Building Observations Survey ©2016

Deer Park Community Center Deer Park, Texas

**Building Survey for Deer Park Community Center,
610 East San Augustine Street, Deer Park, Texas**

**DEER PARK COMMUNITY CENTER
REVIEW AND ASSESSMENT REPORT**

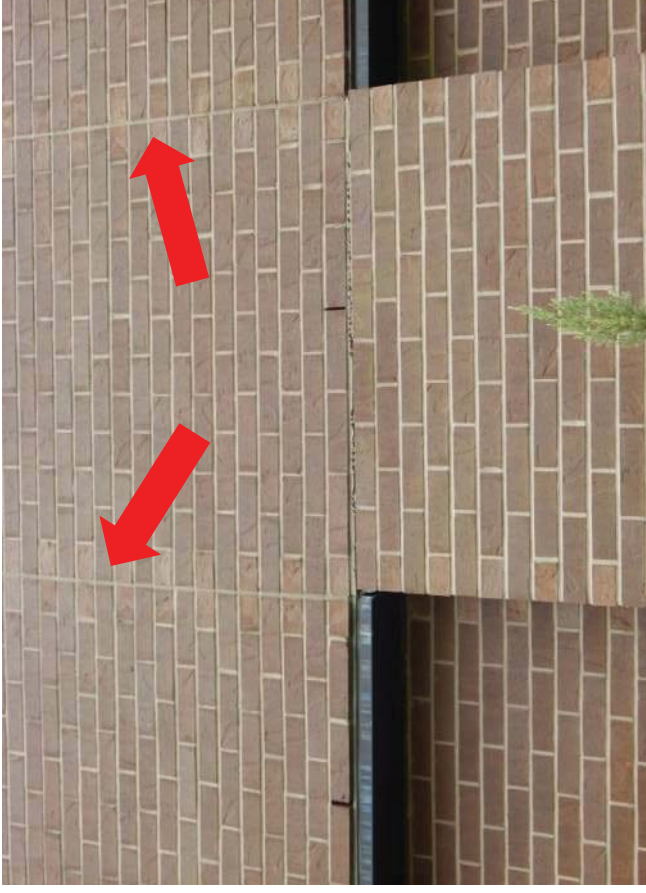
#1 Photo of front entry

#2 Minor separation in caulk joint at end of inset brick panel.
No brick header per architect's detail.

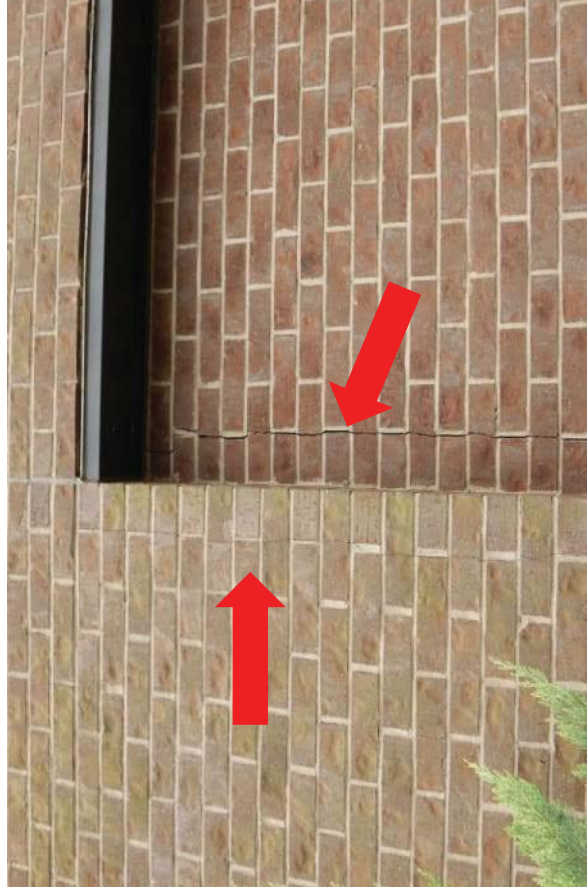
#9 Same as photo #8 showing step crack in brick and vertical crack in phase one that has been repaired.

#10 Same as photo #9 at bottom of crack repair and separation in caulk joint.

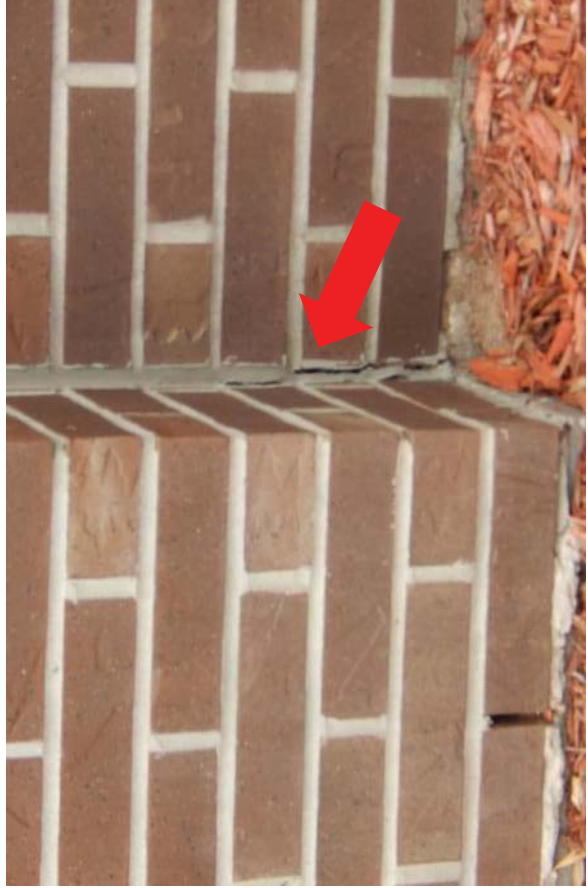
#15 Vertical crack in brick column and in brick inset panel.

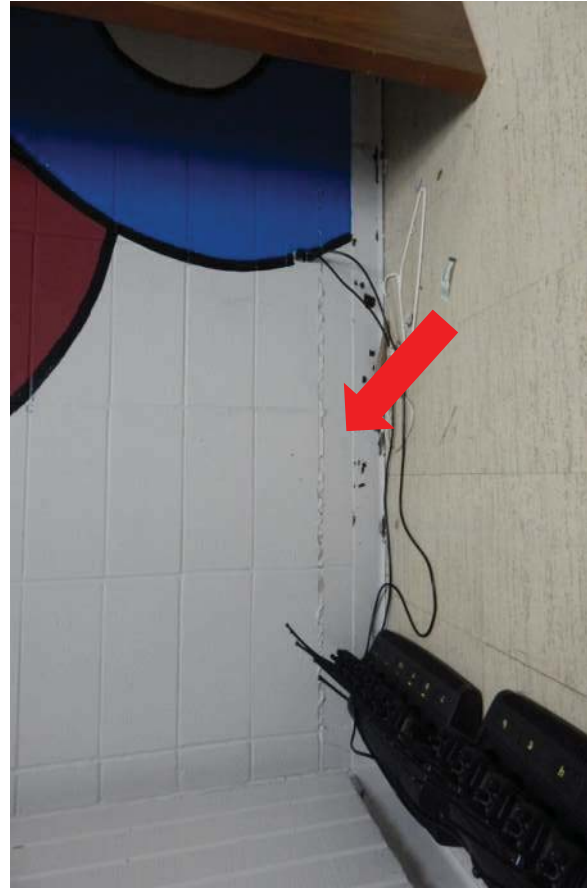
#42 A visible hump up of the floor can be seen in this area

#43 Level on floor showing sloping down toward the North East corner at approximately 1/8" per foot

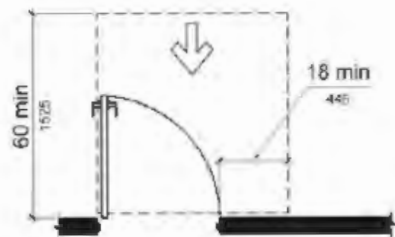
Note: The cross slope of this ramp was measured at 6.5% (3.12:48) The max allowable cross slope is 1:48.

405.3 Cross Slope. Cross slope of ramp runs shall not be steeper than 1:48.
